Comments on #PSP-26-0004 - Planning & Zoning: Preliminary Subdivision Plat

Application Number: #PSP-26-0004
Application Type: Preliminary Subdivision Plat
Date: September 14, 2026
Address: 408 E YOUNG ST, ROLESVILLE, NC 27571
Parcel: 1768098727

Rolesville Town Campus

PRELIMINARY SUBDIVISION PLAT - SUBMITTAL #1

OVERALL EXISTING
CONDITIONS &
DEMOLITION PLAN

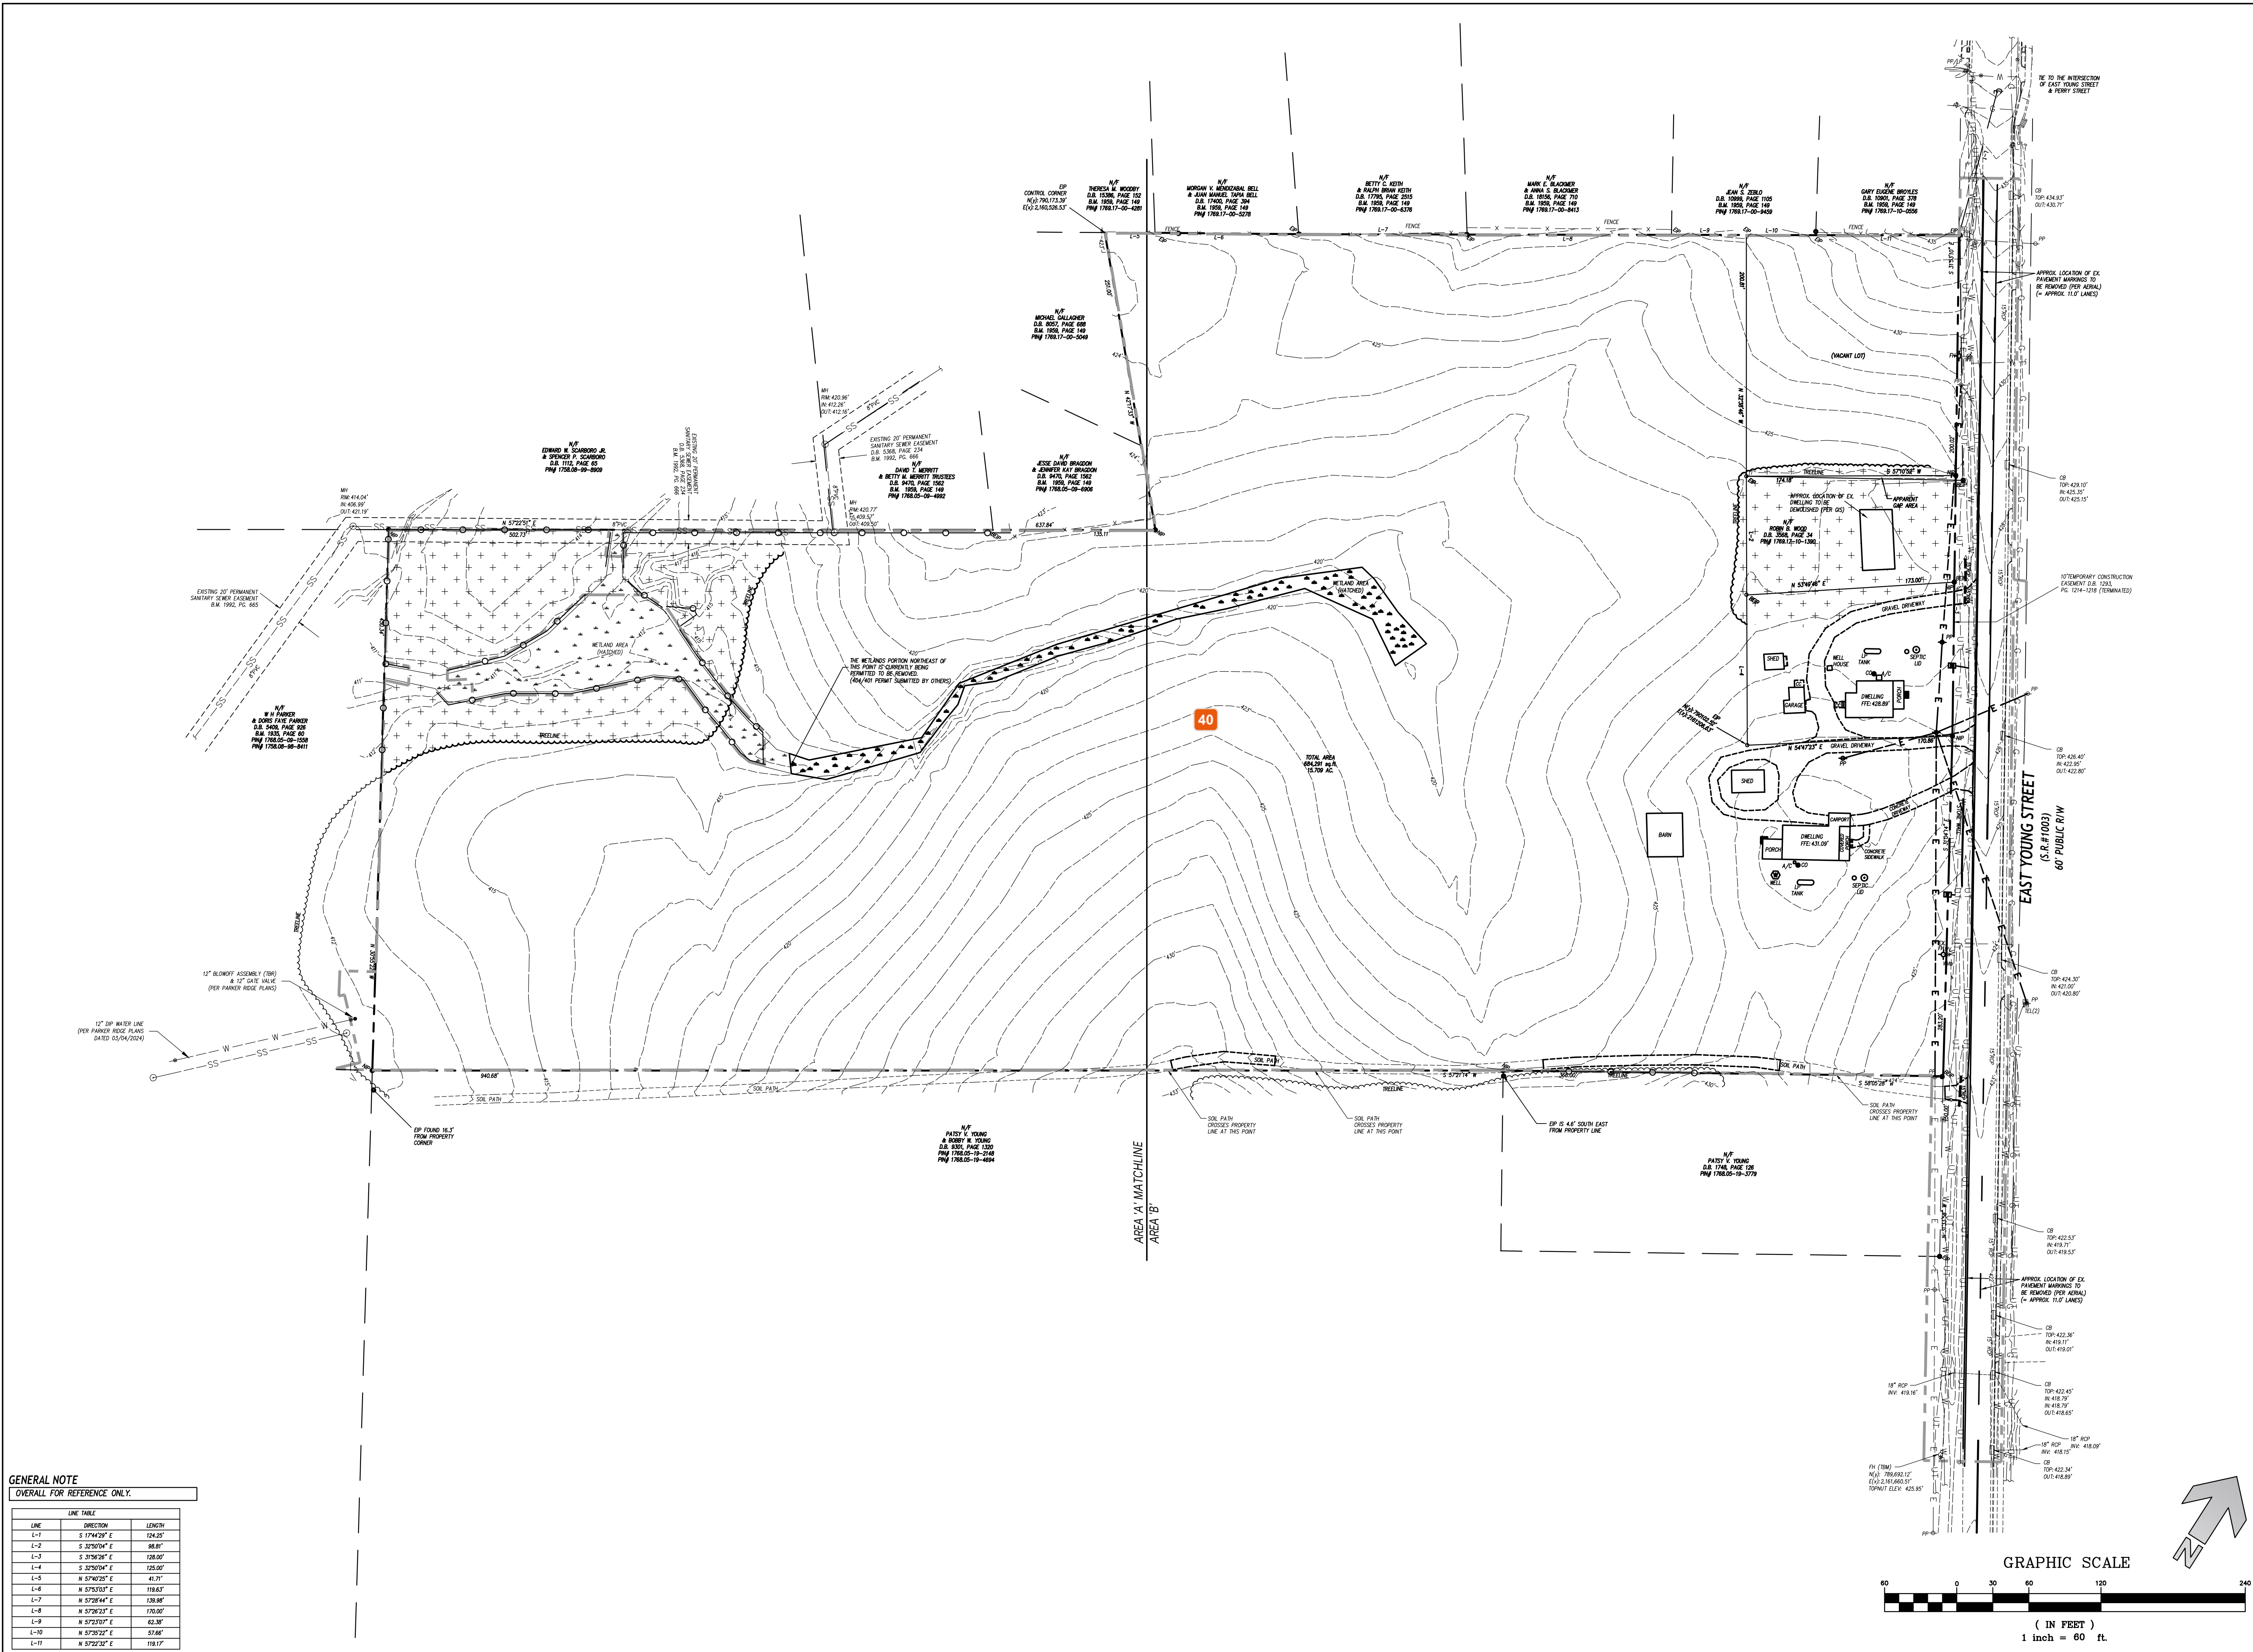
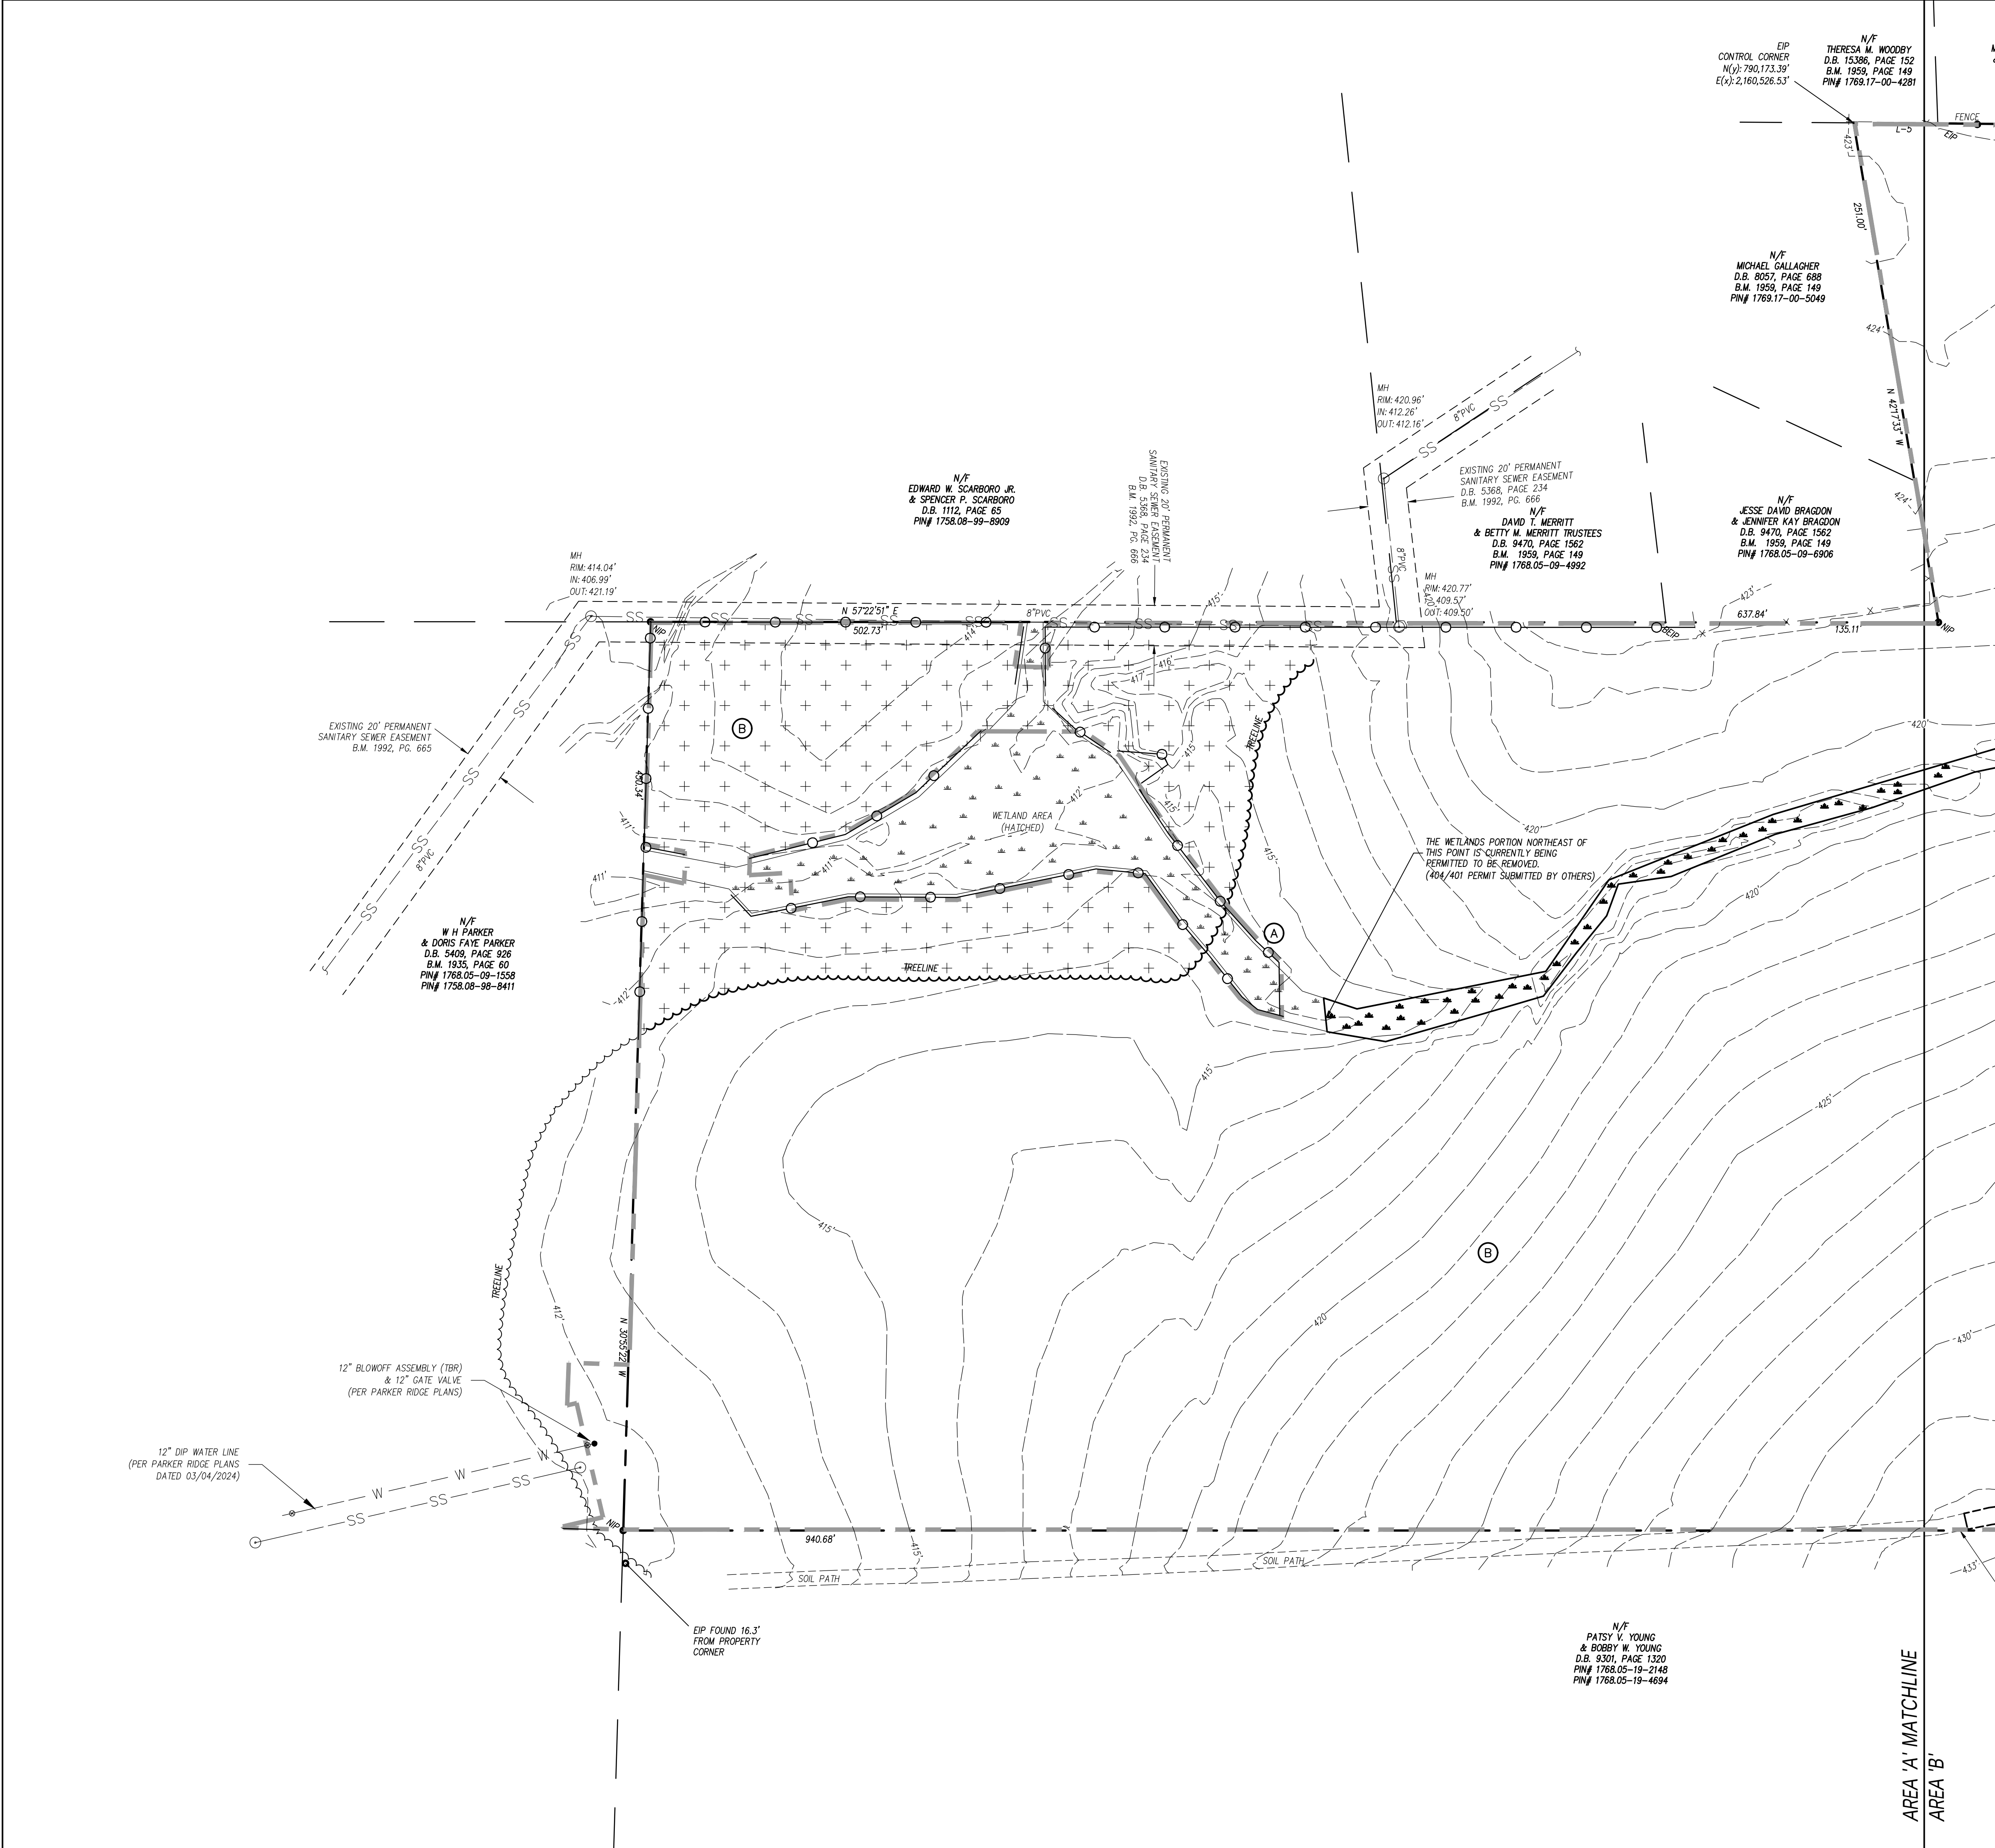
Indicate with labels or notes there are separate areas / zoomed in sheets to clarify demolition. Example, shade/ outline and label "Area A" and "Area B"

C-3.00

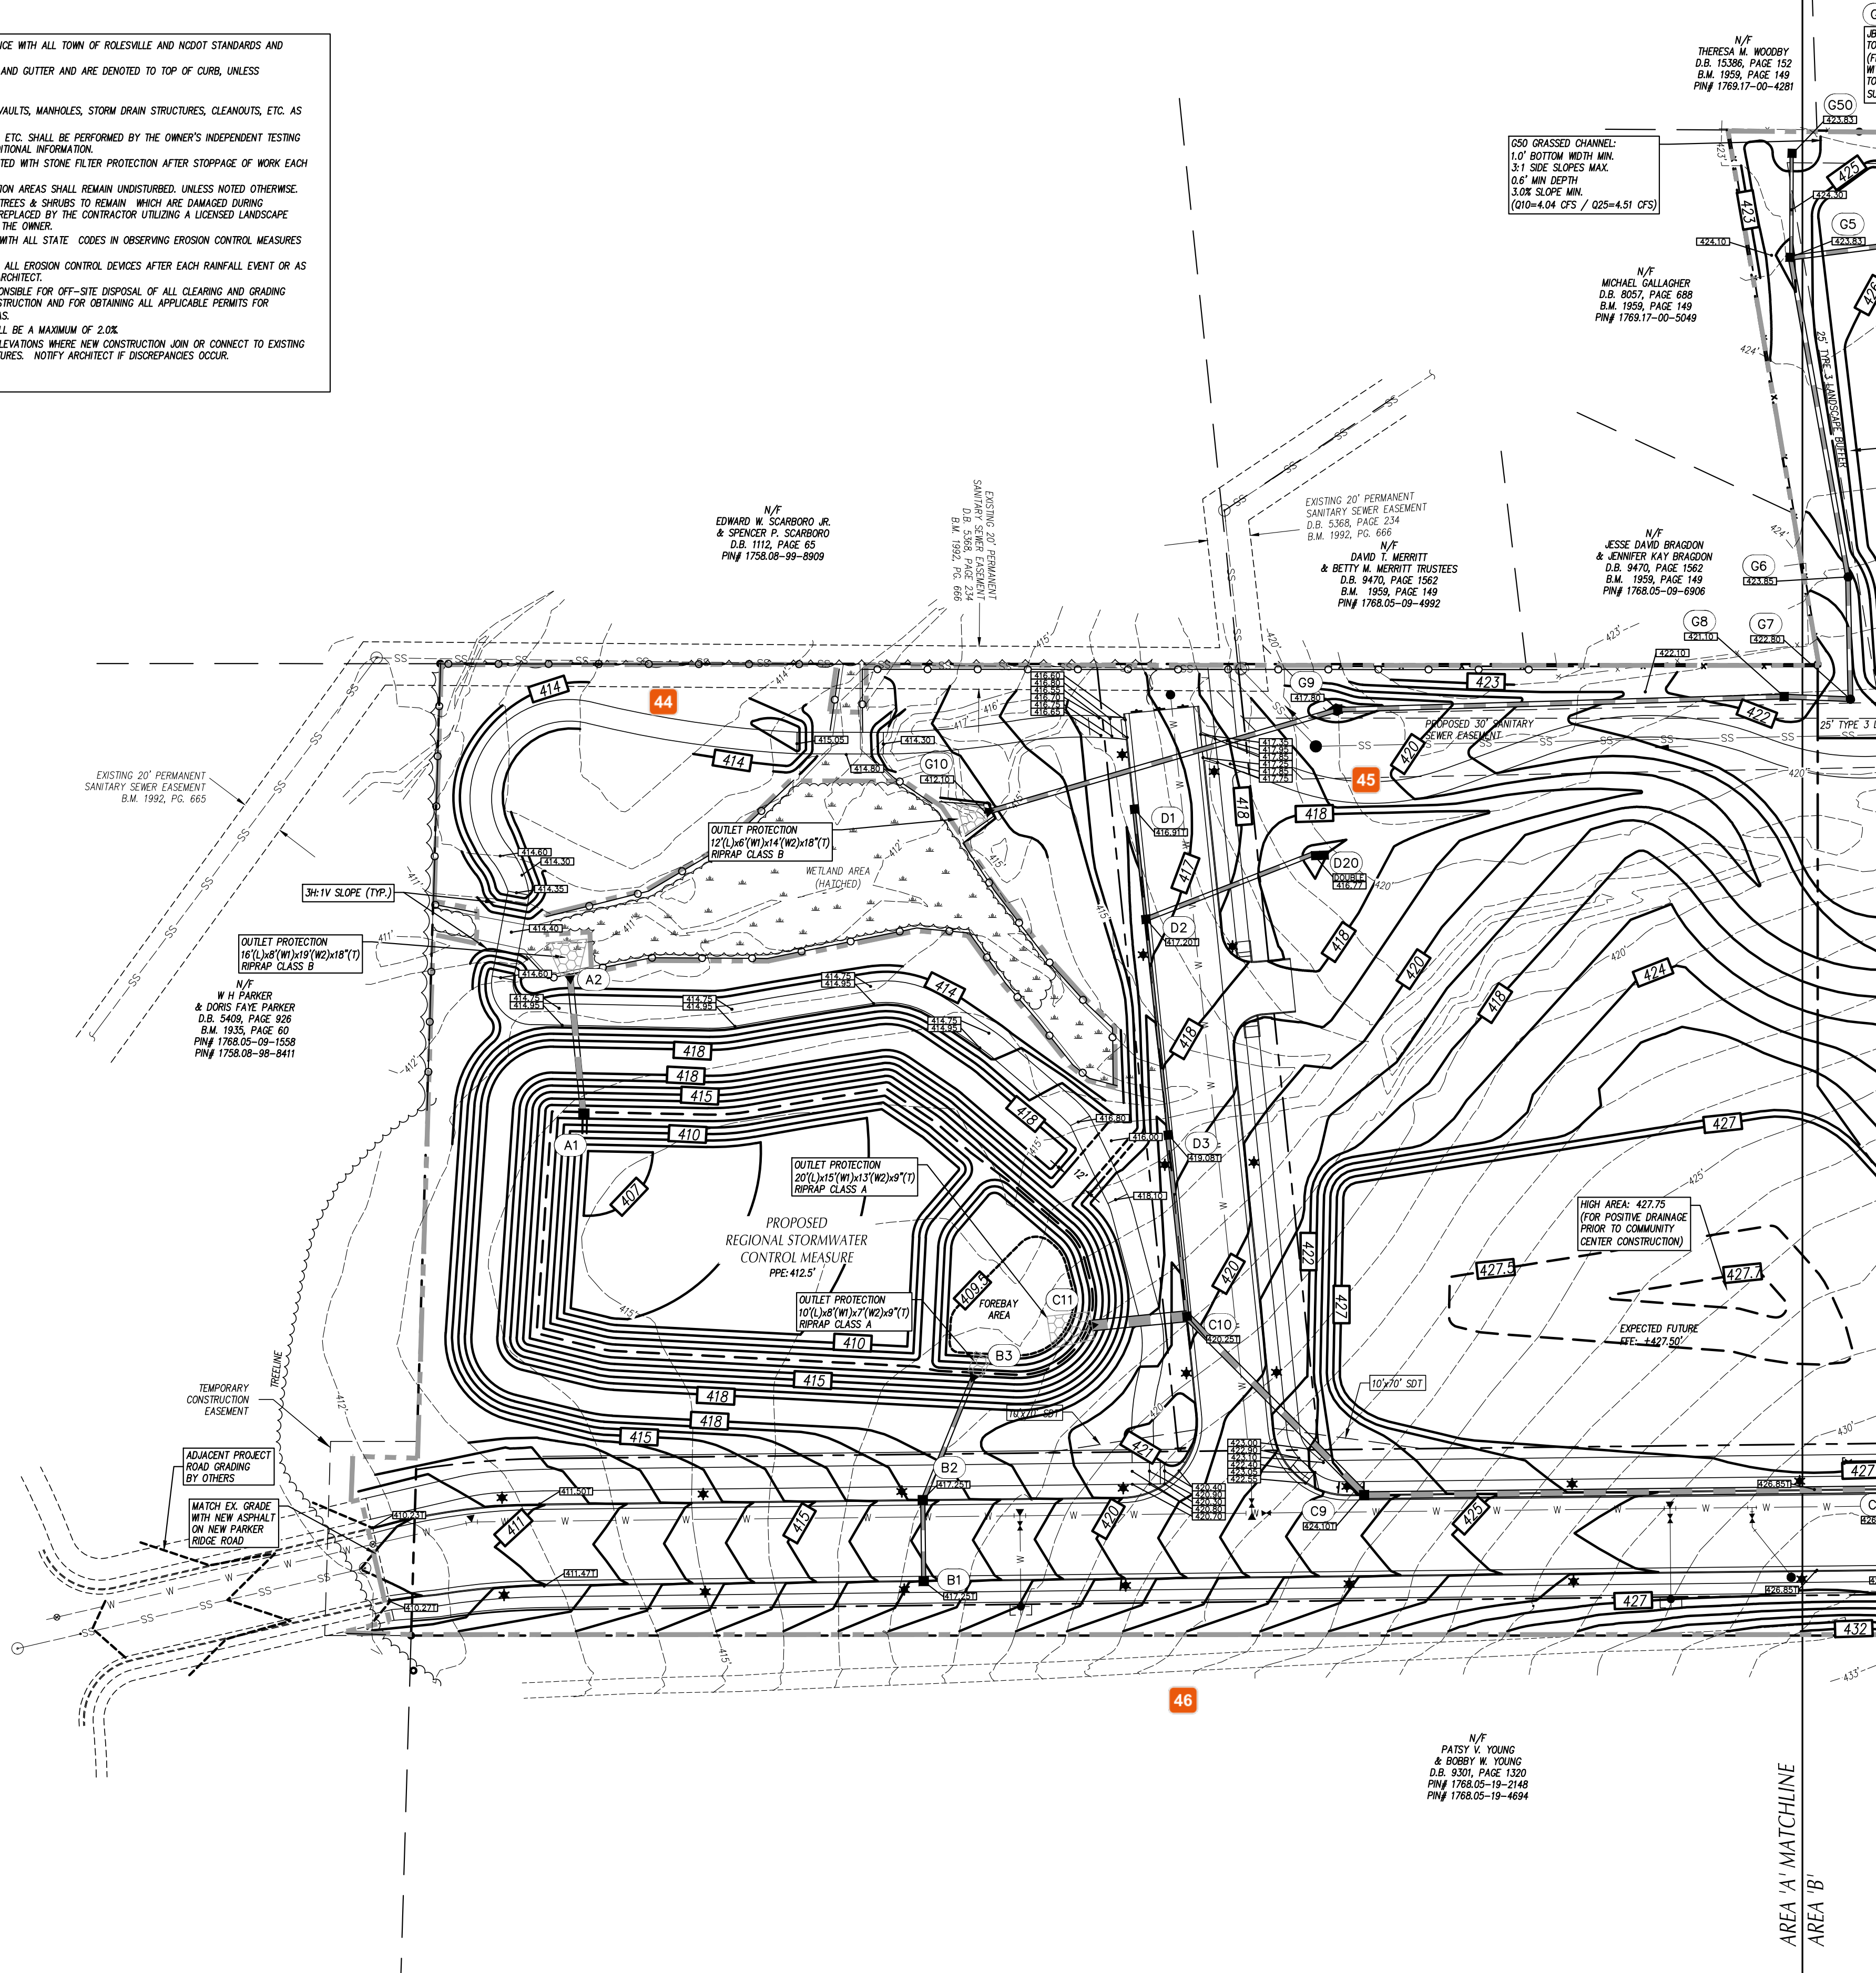
41 Jacqueline Thompson
Please confirm/label what these dots represent.

42 Jacqueline Thompson
Please confirm all proposed labels are tying into existing.

43 Jacqueline Thompson
Is this dumper proposed with this phase? Please review and clarify.
